Access Compliance Report

Public Rights-of-Way

Intersection ID: 23730	Main Street: PROVIDENCE_RD	Cross Street: CEDAR_CROFT_DR	Location: SW
ADA ID: 3B987E0C2AC1	Ramp Type: Perp	Initial Pass/Fail: Fail	Overall Compliance: No
Severity Score: 48.75			
Codes/Mitigation Info/Possible Solution		Field Measurements/Component Compliance

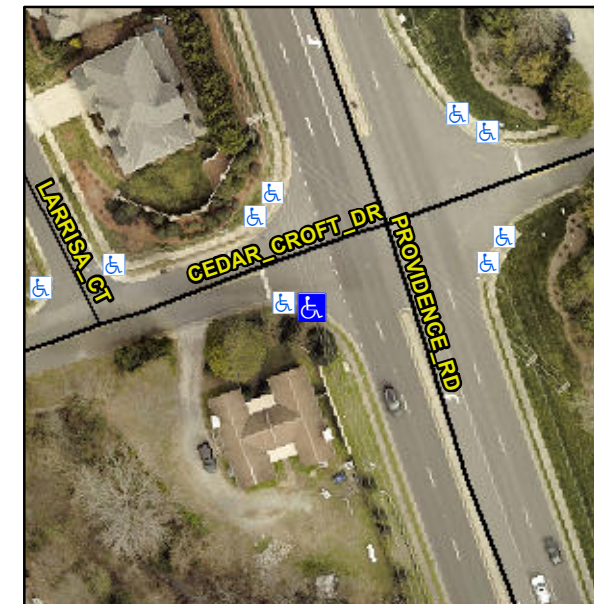
R304.5.1, R304.2.2

Compliance	Description	Data	Compliance	Description	Data
N/A	Ramp Length (in)	71.0	No	Ramp Slope (%)	10.6
No	Ramp Width (in)	31.0	Yes	Ramp XSlope (%)	2.1
N/A	Flare Type LT	N/A	N/A	Flare Type RT	N/A
N/A	Flare Slope LT (%)	N/A	N/A	Flare Slope RT (%)	N/A
N/A	Flare Traversable LT?	N/A	N/A	Flare Traversable RT?	N/A
N/A	Landing Length (in)	N/A	N/A	DWS Provided?	N/A
N/A	Landing Width (in)	N/A	N/A	DWS Contrast?	N/A
N/A	Landing Slope (%)	N/A	N/A	DWS Length (in)	N/A
N/A	Landing X Slope (%)	N/A	N/A	DWS Full Width?	N/A
N/A	Landing Curb? (Y/N)	N/A	N/A	DWS Offset (in)	N/A
N/A	Shared Landing?	N/A			
N/A	Gutter Ponding?	N/A	N/A	Gutter Slope (%)	N/A
N/A	Gutter Lip Ht (in)	N/A	N/A	Gutter X Slope (%)	N/A
N/A	Painted X Walk1?	No	N/A	Painted X Walk2?	N/A
	X Walk 1 Direction	To E		X Walk 2 Direction	N/A
N/A	X Walk 1 Width (in)	N/A	N/A	X Walk 2 Width (in)	N/A
	X Walk 1 Slope (%)	4.5		X Walk 2 Slope (%)	N/A
	X Walk 1 X Slope (%)	3.1		X Walk 2 X Slope (%)	N/A

Remove & Replace Entire Ramp.
